121 LAFAYETTE AVE.  
WHITE PLAINS, NEW YORK 10603  
SECTION 122.12 BLOCK 1 LOT 39

**SITE PLAN**

RE: 121 Lafayette Ave.- Staff Report September 27, 2021 Response to Comments

**121 Lafayette Ave** [2021-022] – Site Development Plan for Rooftop Solar

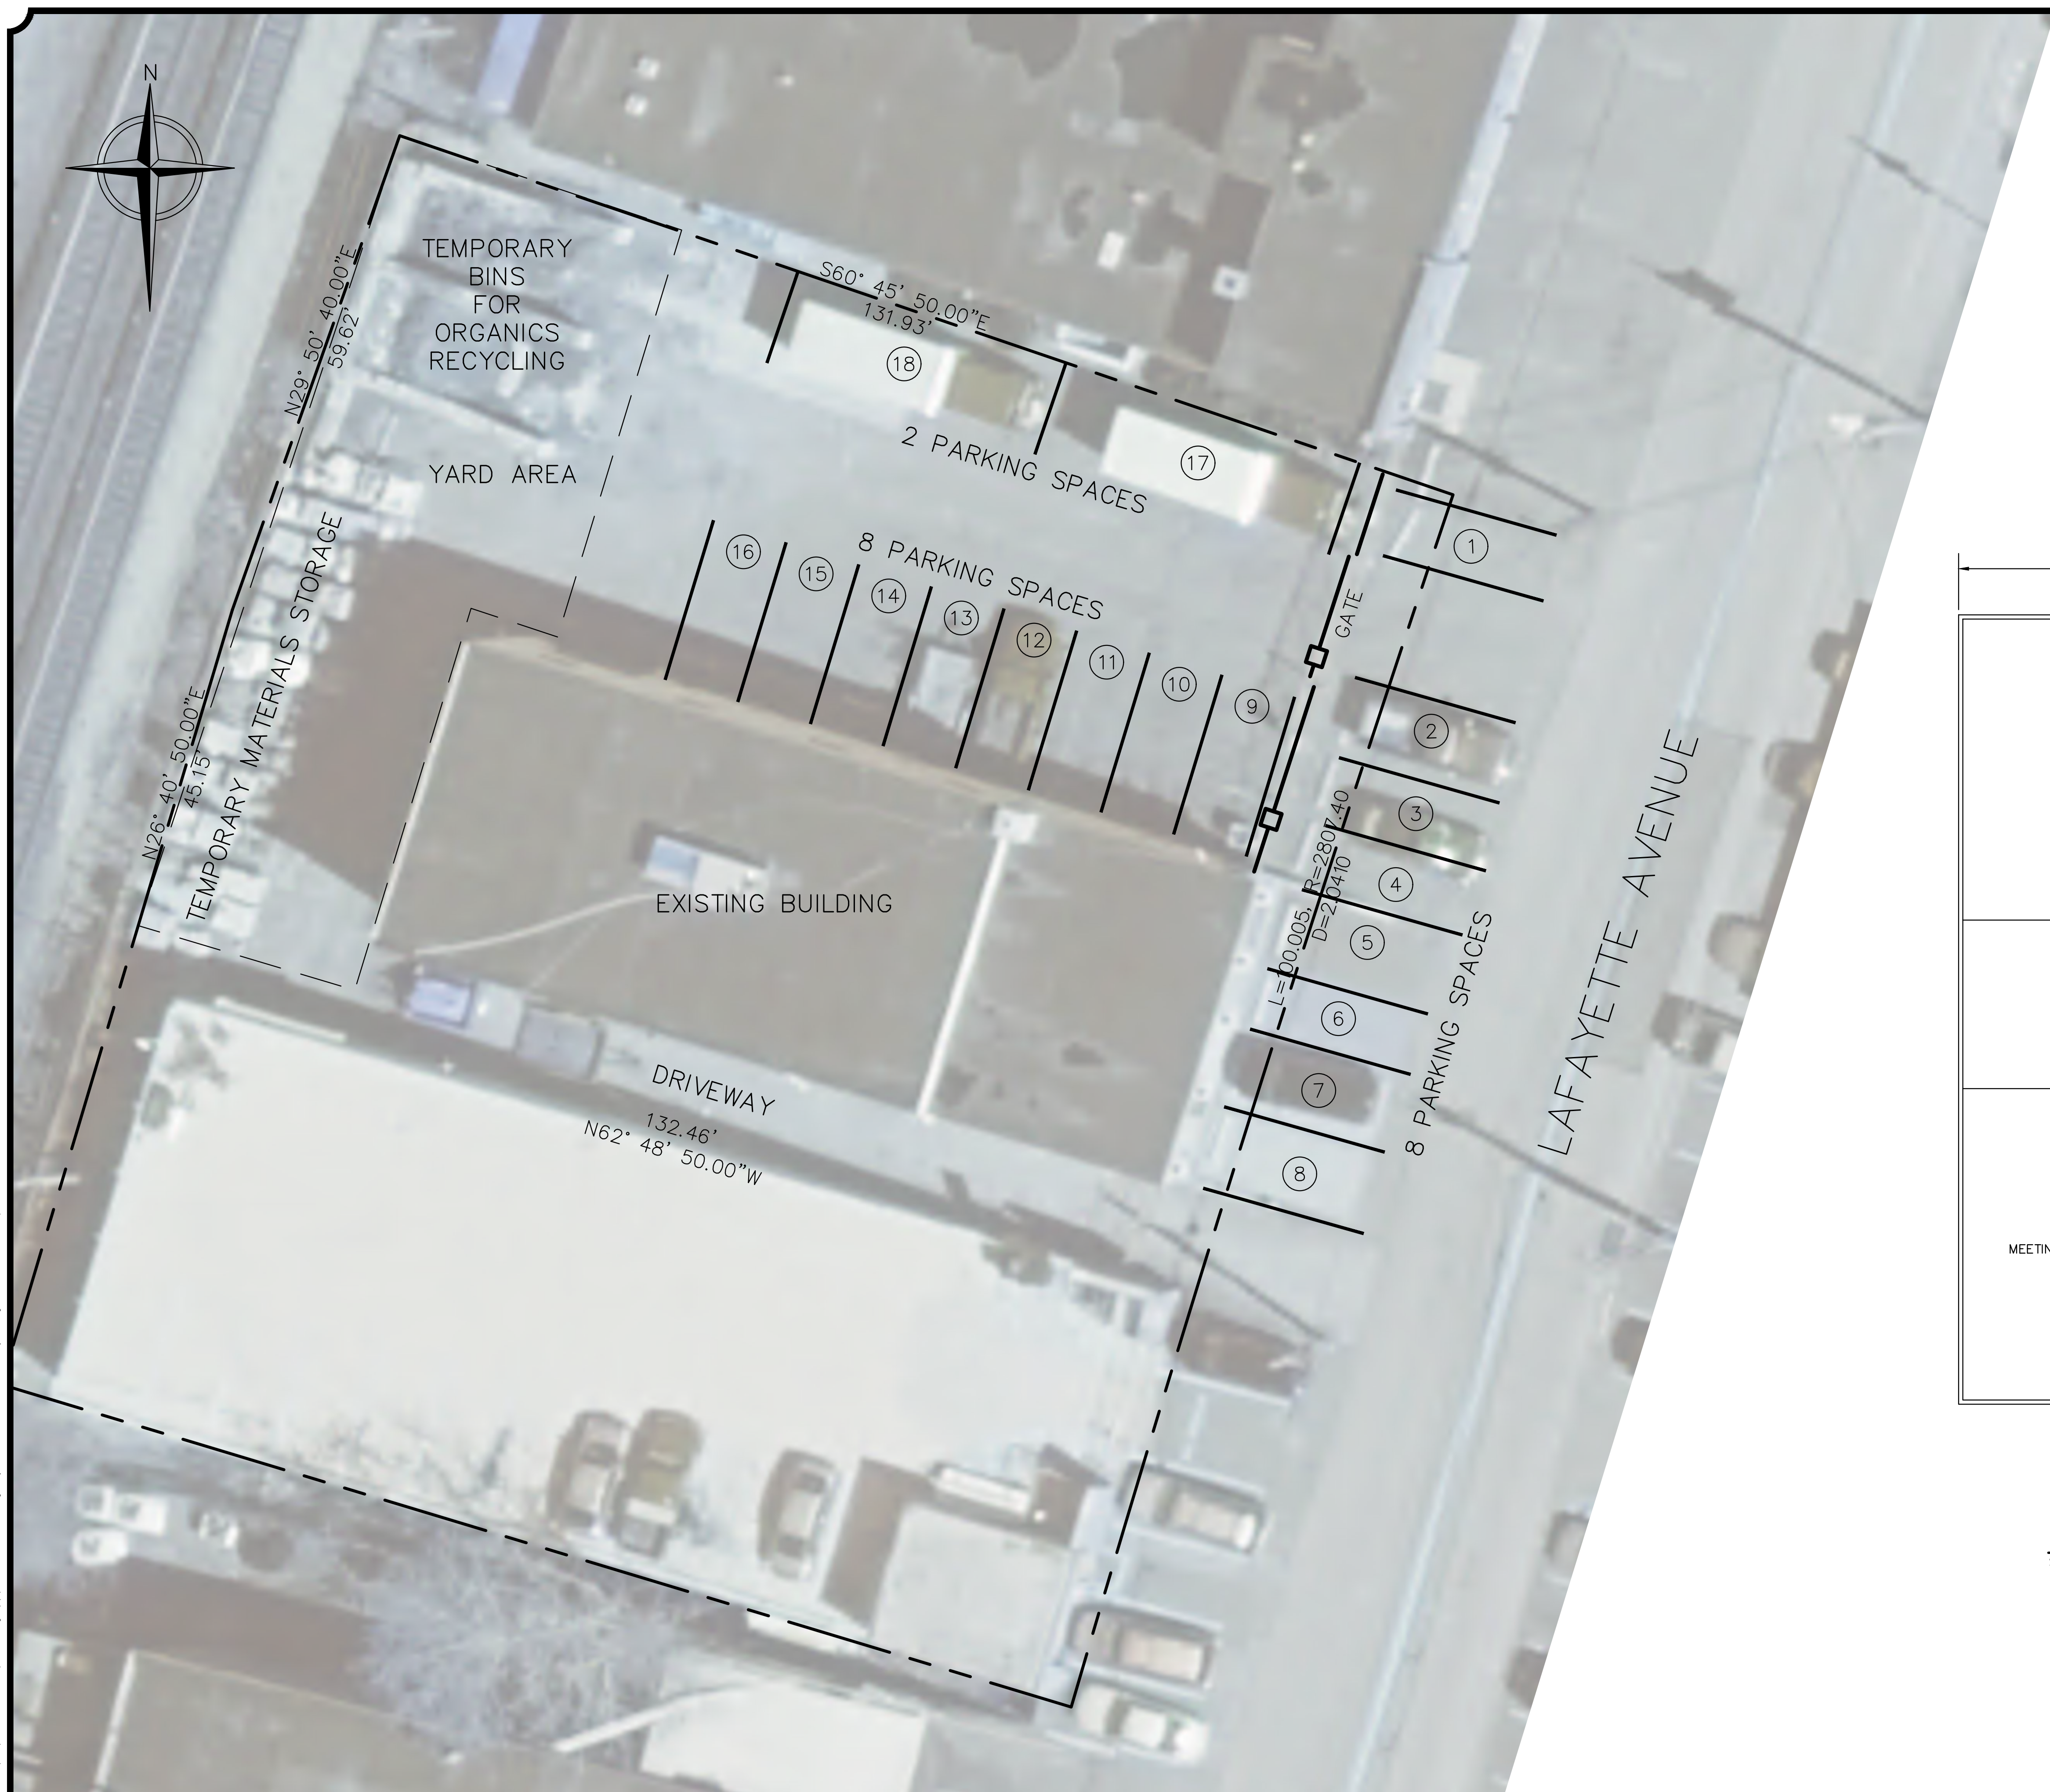
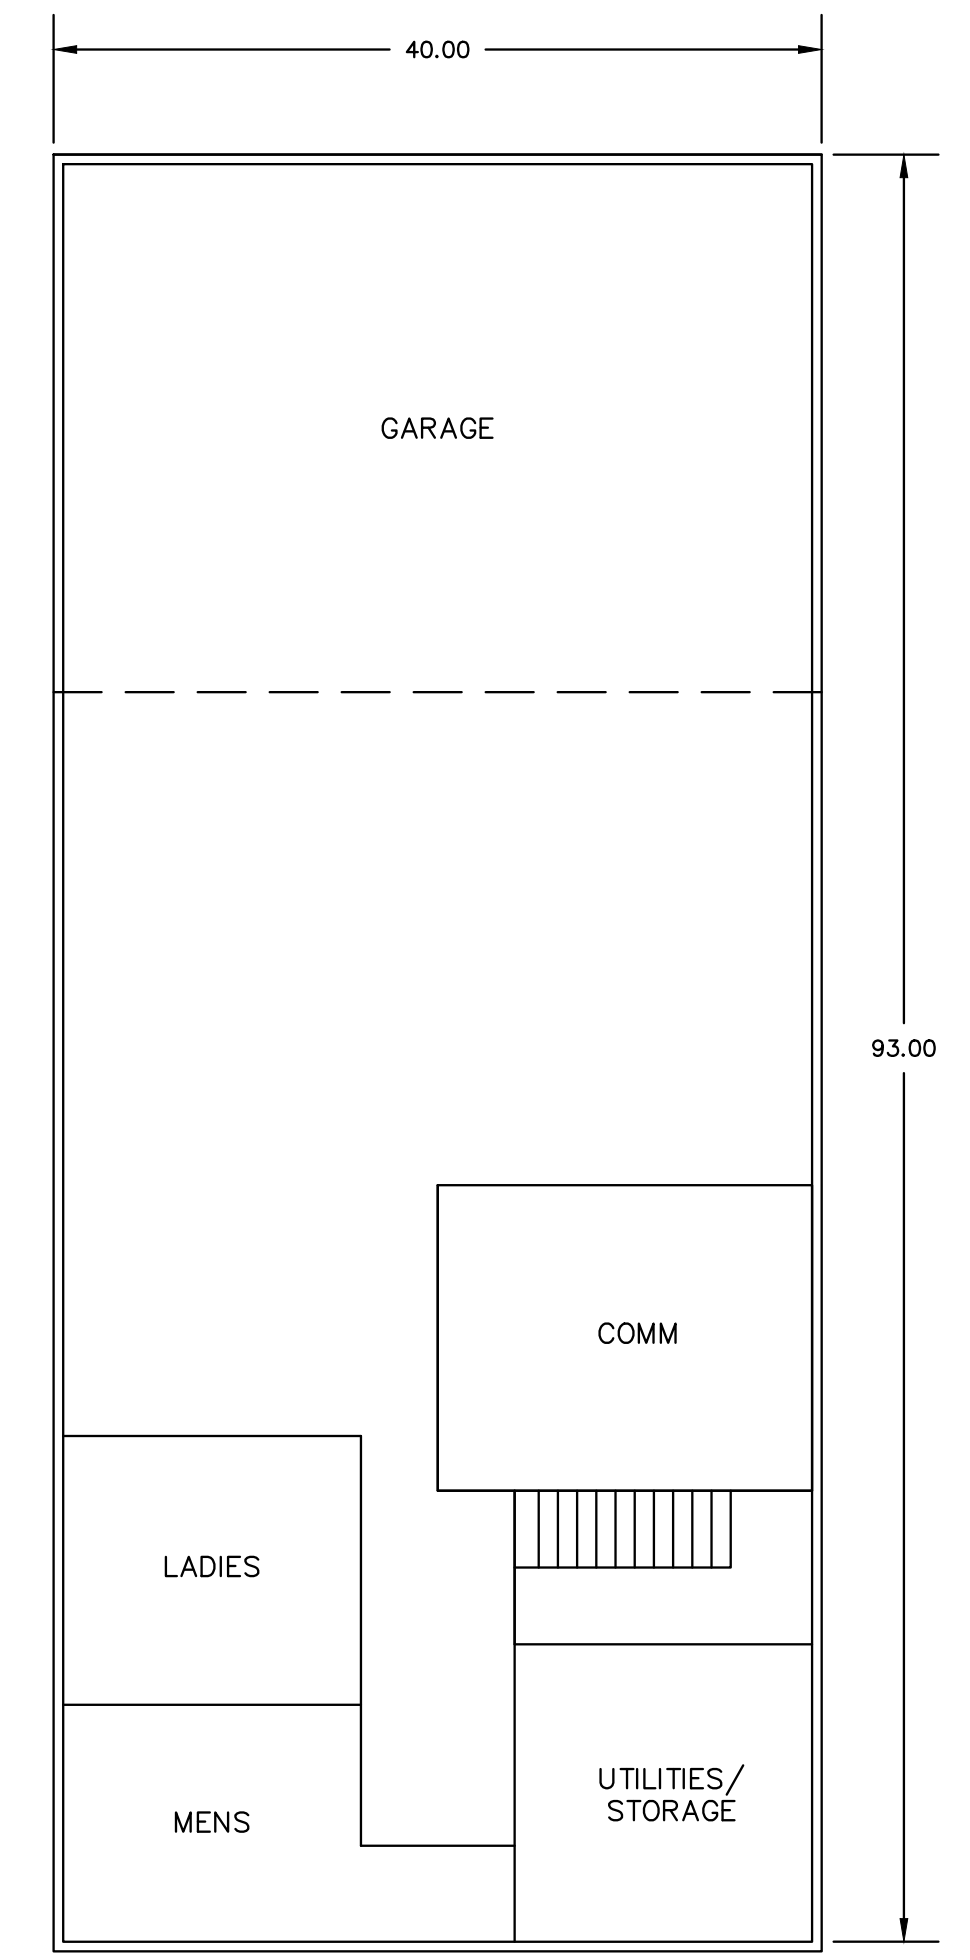
2. A total of 18 off-site parking spaces are required. 8 of these spaces are located on the street and 10 are located on 123 Lafayette Ave next to the office building. A variance is currently being sought to allow for parking on the street.

3. The yard area has been separated from the parking areas on the revised site plan.
4. The yard area used for materials storage and organic recycling are part of Bellantoni’s landscaping operations. The yard area is approximately 3,050 SF as shown in the revised site plan. 119, 121, and 123 Lafayette Ave. owned by Bellantoni Landscape total 19,863 SF. The yard area is approximately 15% of the total owned lot area. There is a gate typically closed to Lafayette Ave. which screens the back of the property where the yard is located.

OFFICE SPACE 3,720 S.F./250 S.F. = 15 SPACES  
WAREHOUSE SPACE 3,720 S.F./1,200 S.F. = 3 SPACES  
18 PARKING SPACES REQUIRED
